**Design Review & Historic Preservation Board
Agenda
November 10, 2022**

Design Review and Historic Preservation Board
Minutes
October 27, 2022

Structure-plan

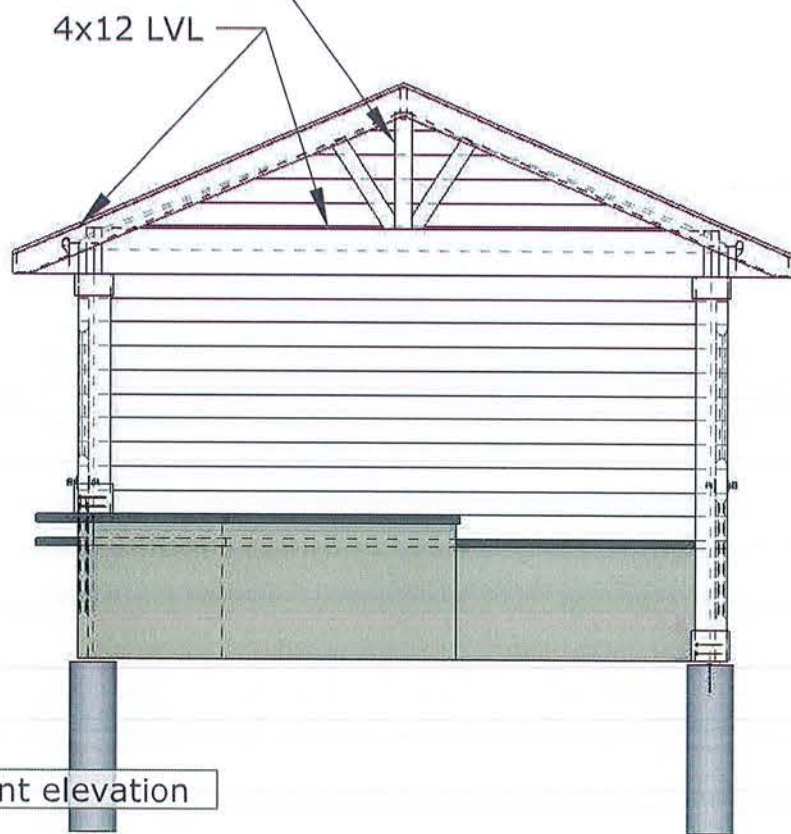
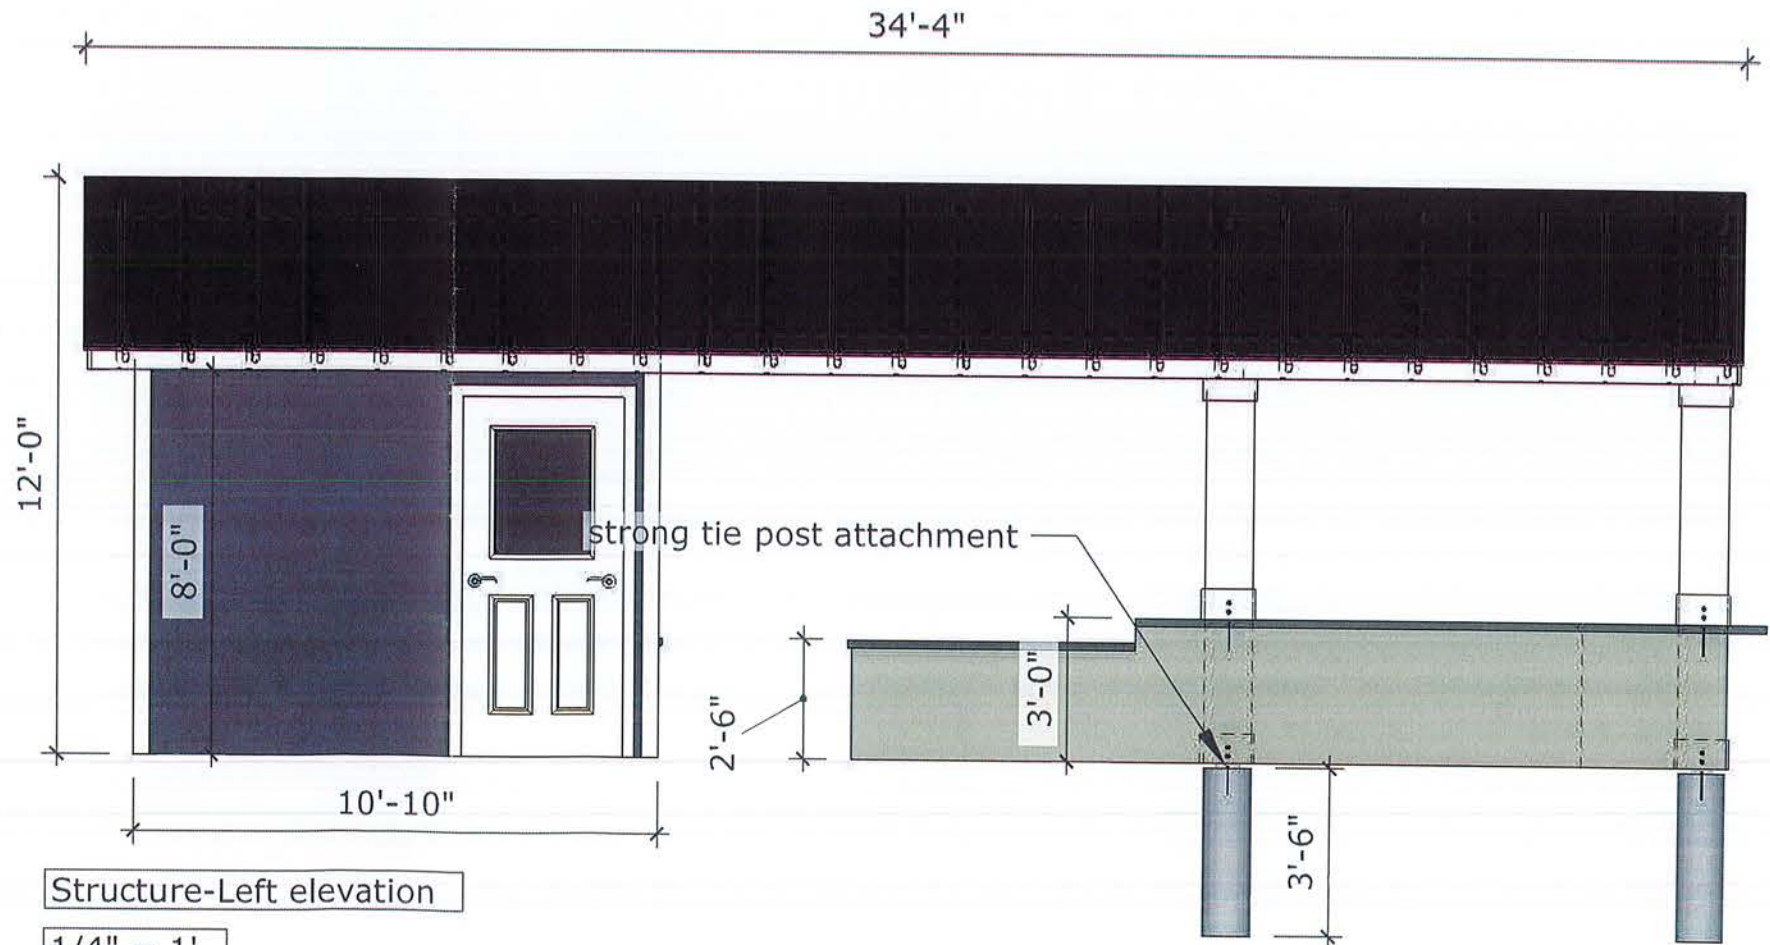
The Board was unclear as to the materials to be used on the accessory structure, so the decision was made to hold the application open pending more information.

FRONT ELEVATION

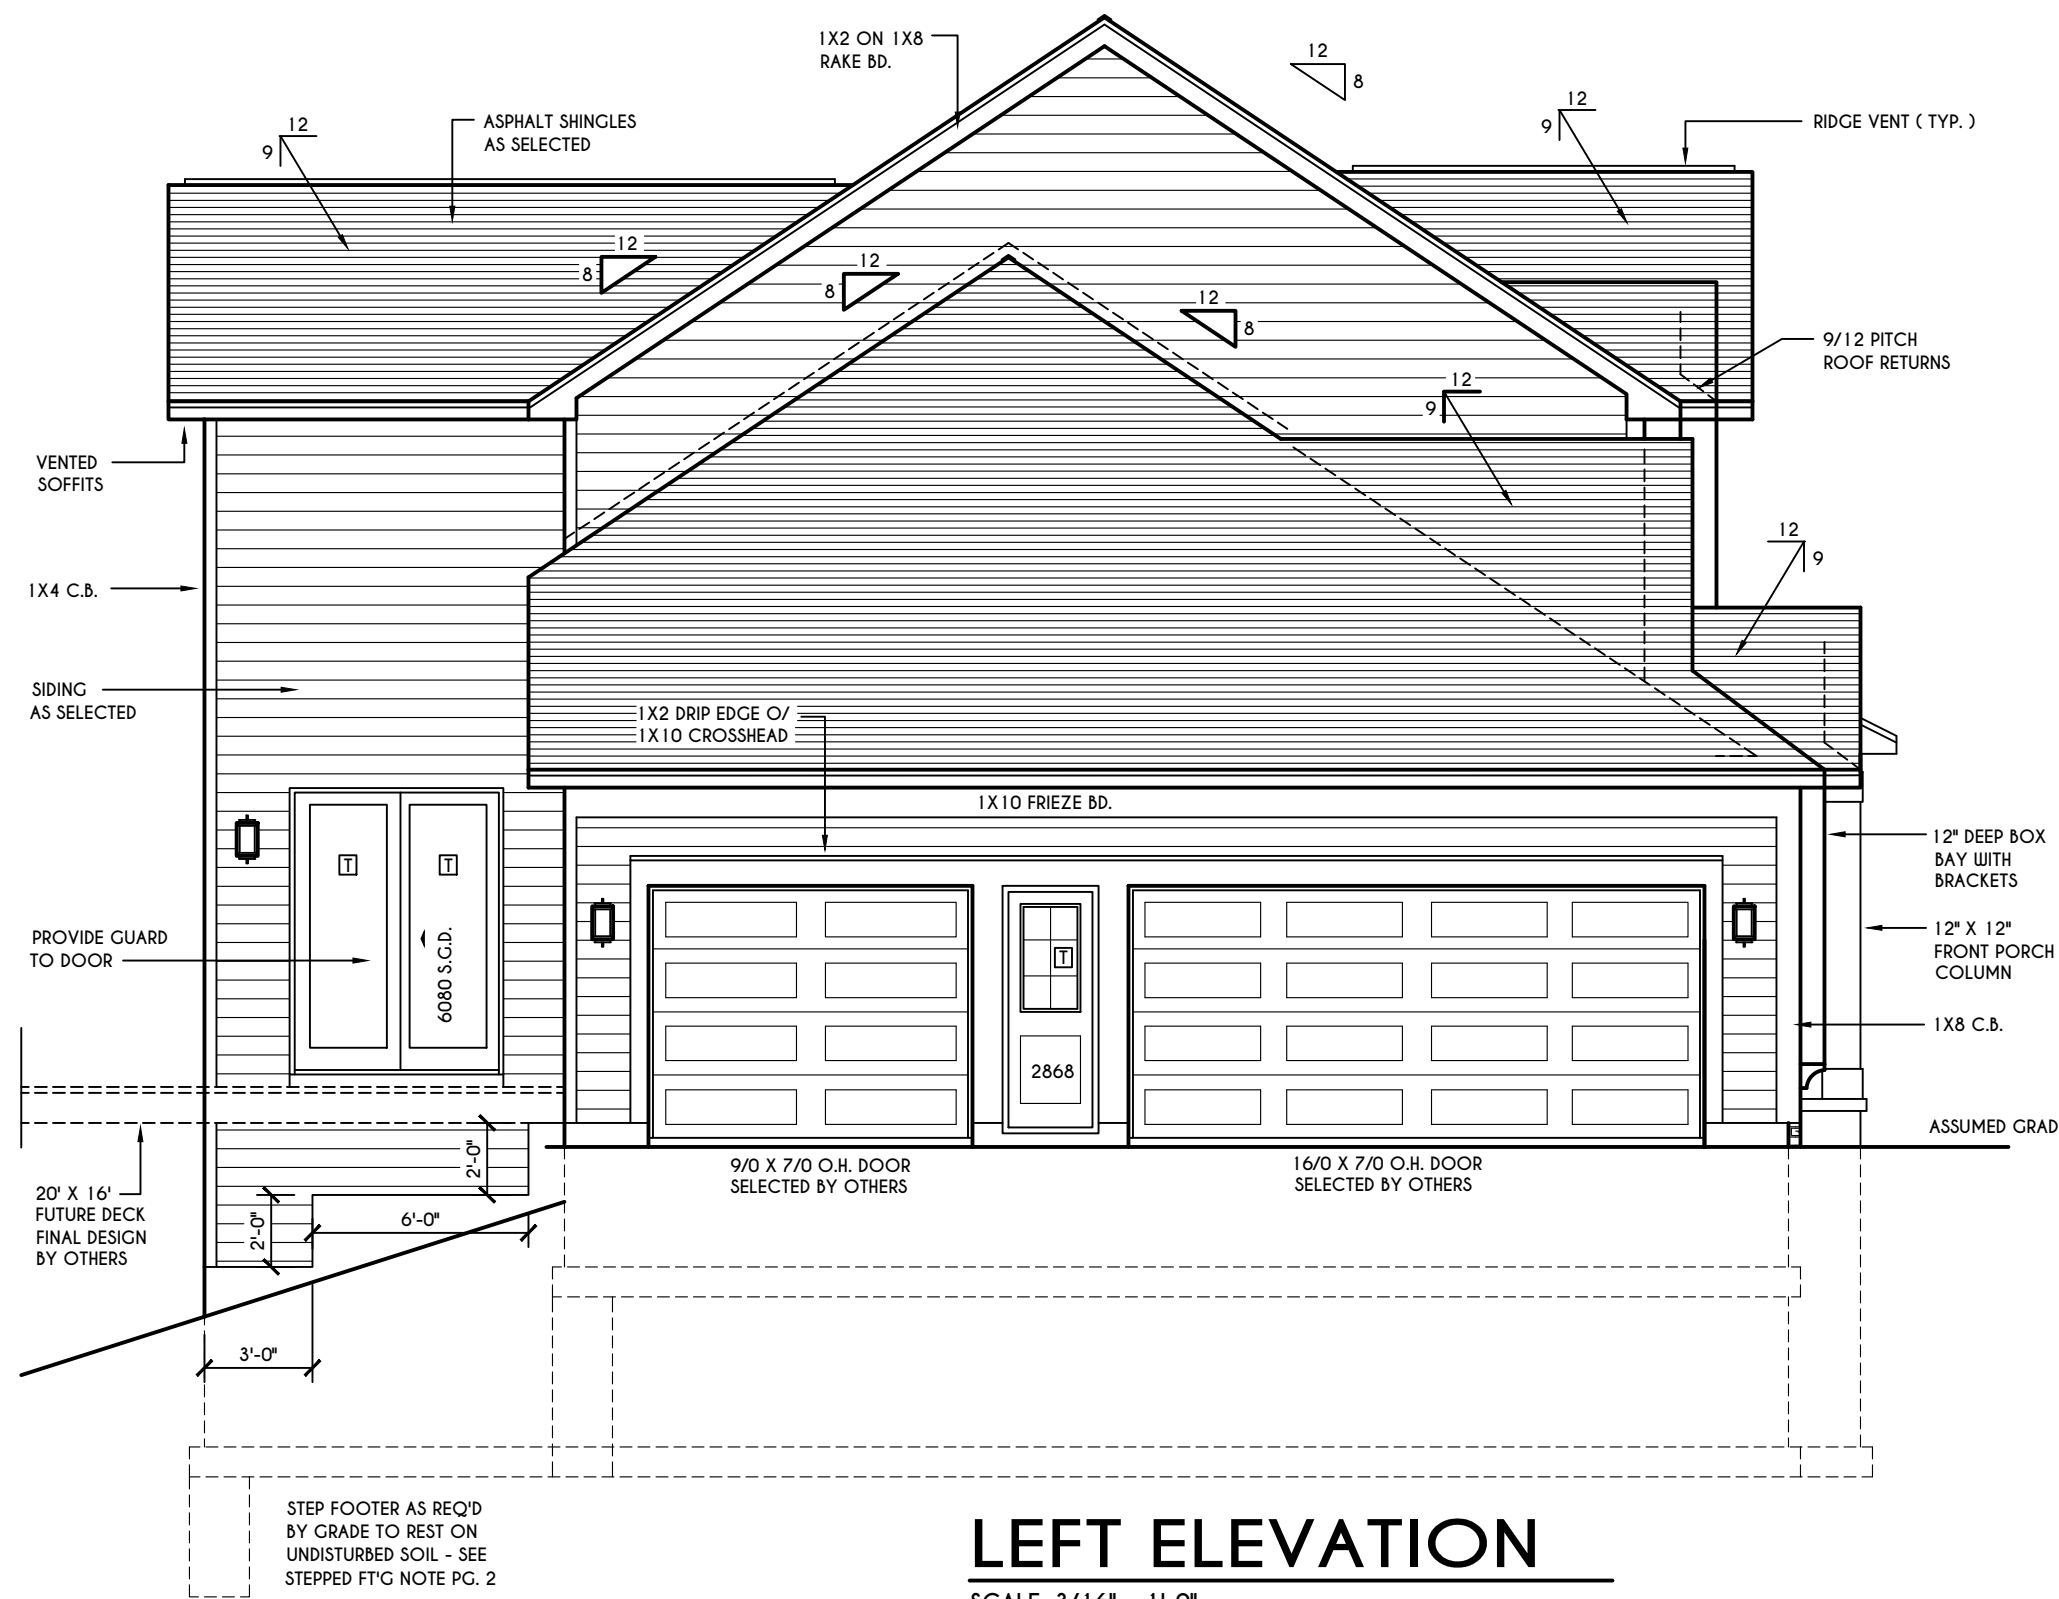
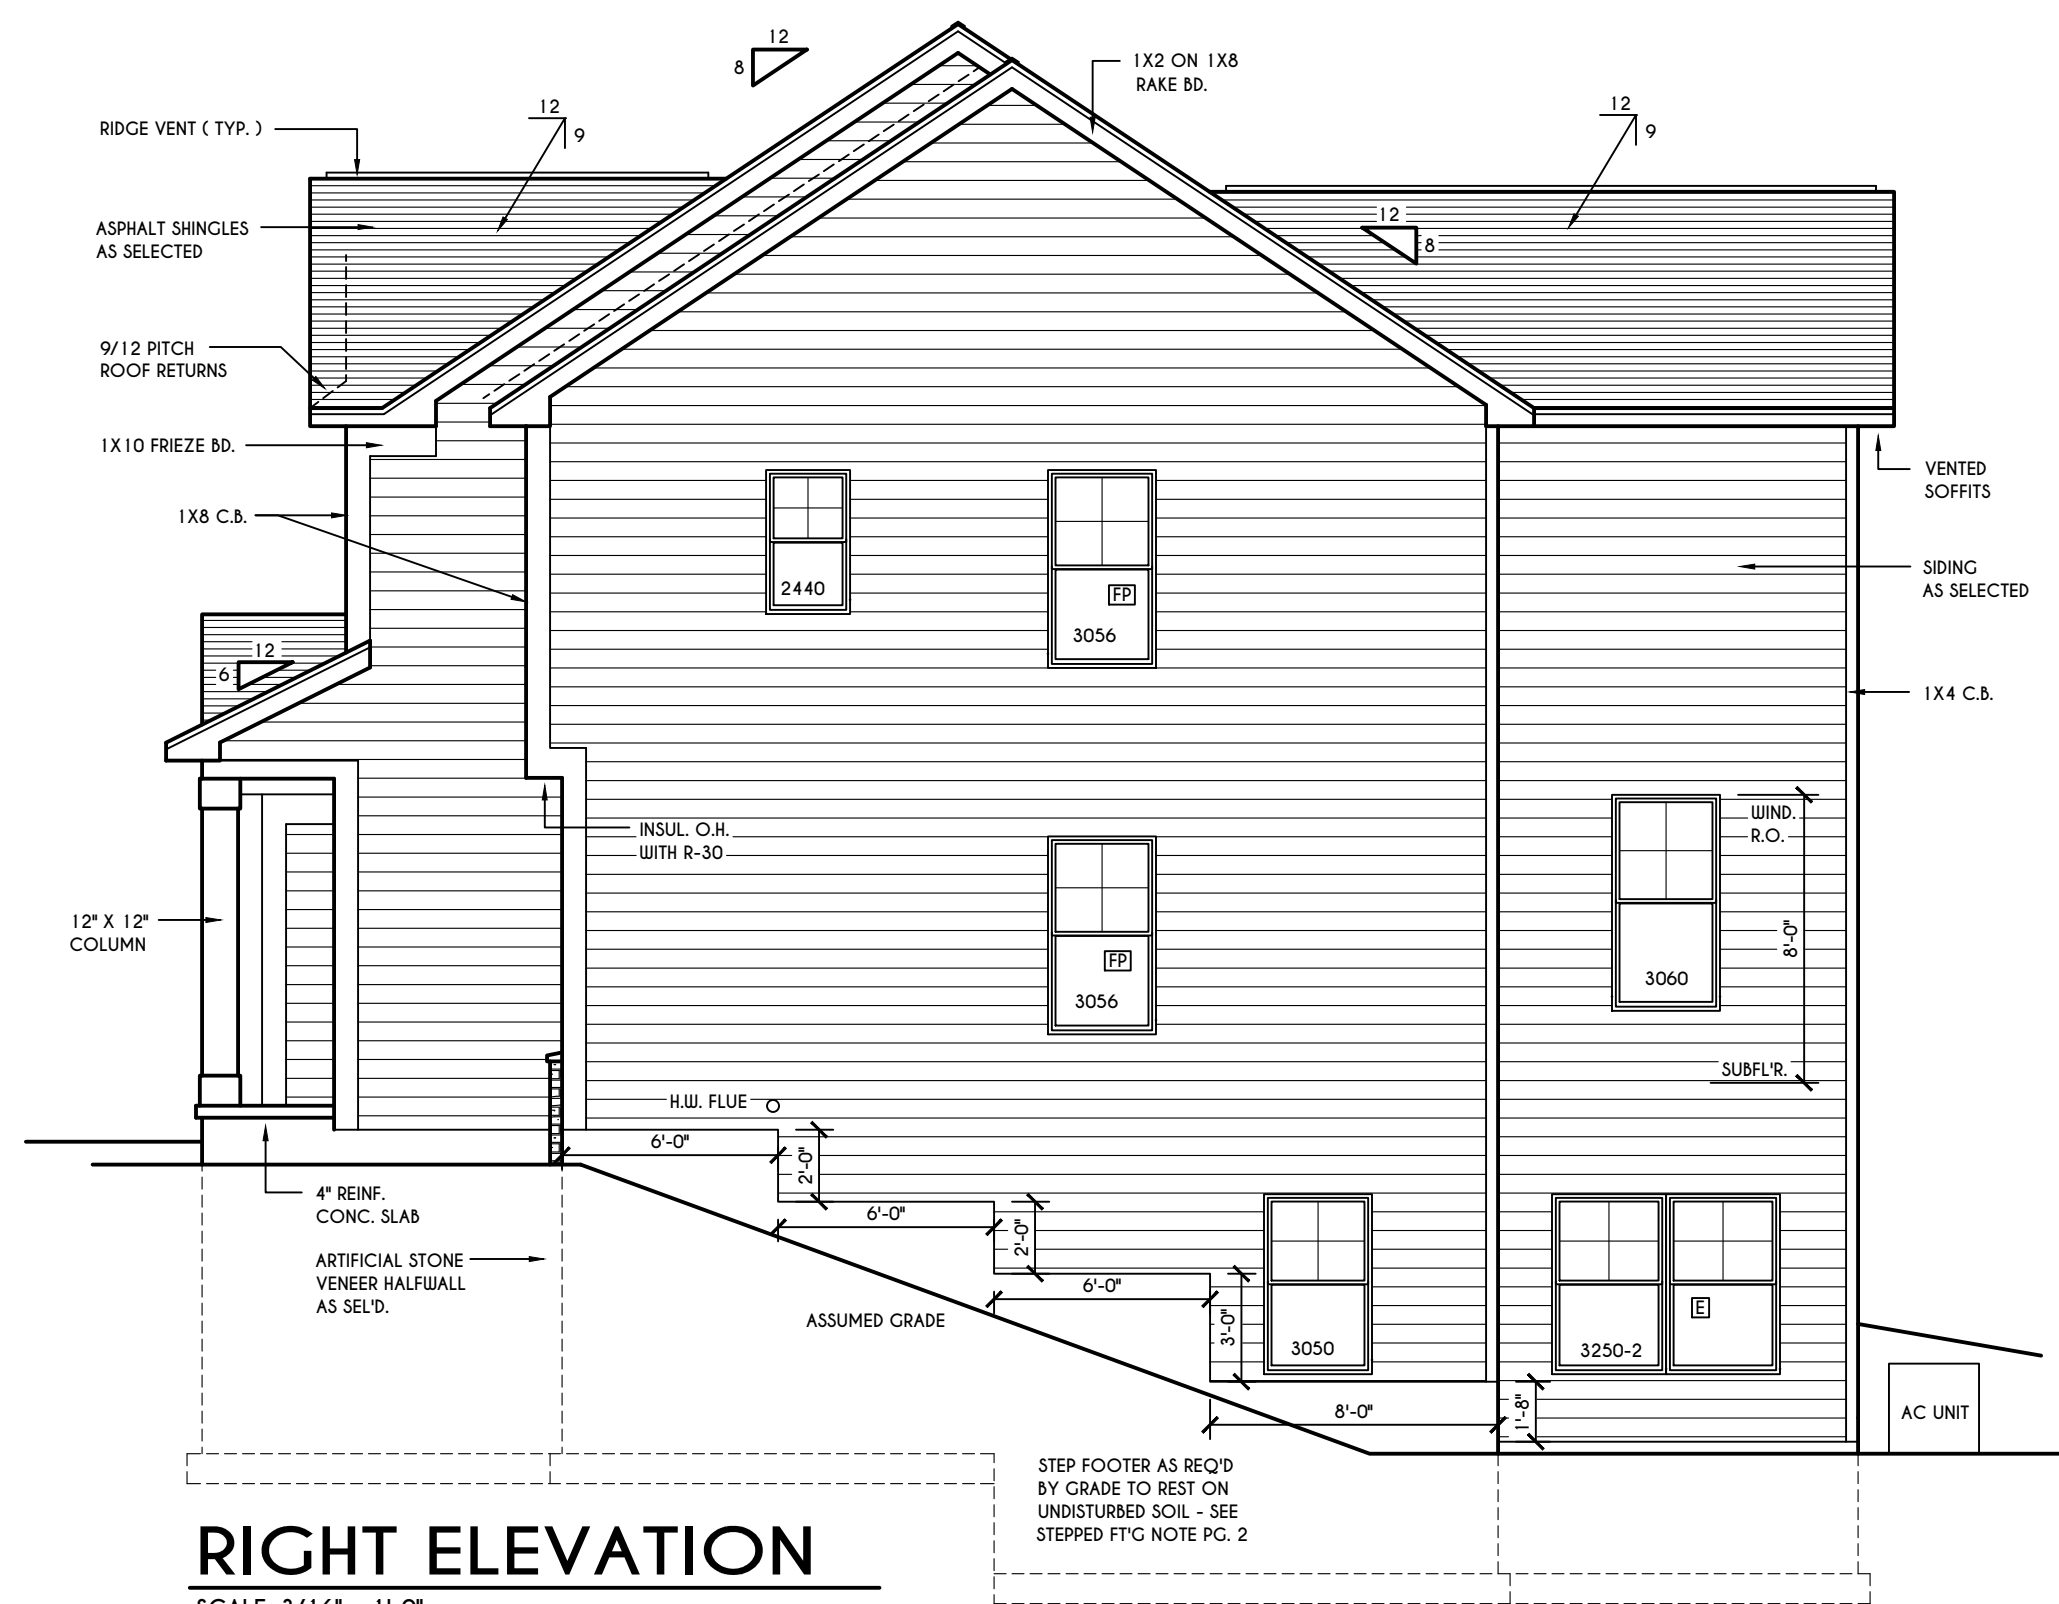
The Board had concerns about the multiple materials utilized on the front elevation. They felt the front elevation is “busy” and preferred 1 or 2 textures as opposed to brick, siding, board and batten and timbers in addition to two roofing materials. Bonnie Salem recommended that the siding replace the board and batten. After discussion, the Board determined that if the color palette is the same and compatible with the brick this design would be acceptable.

David Wigg moved to accept the application as submitted with conditions:

1. The metal roof and asphalt roof will be the same color.
2. The color palette of the materials will be the same color palette and the brick will be compatible.
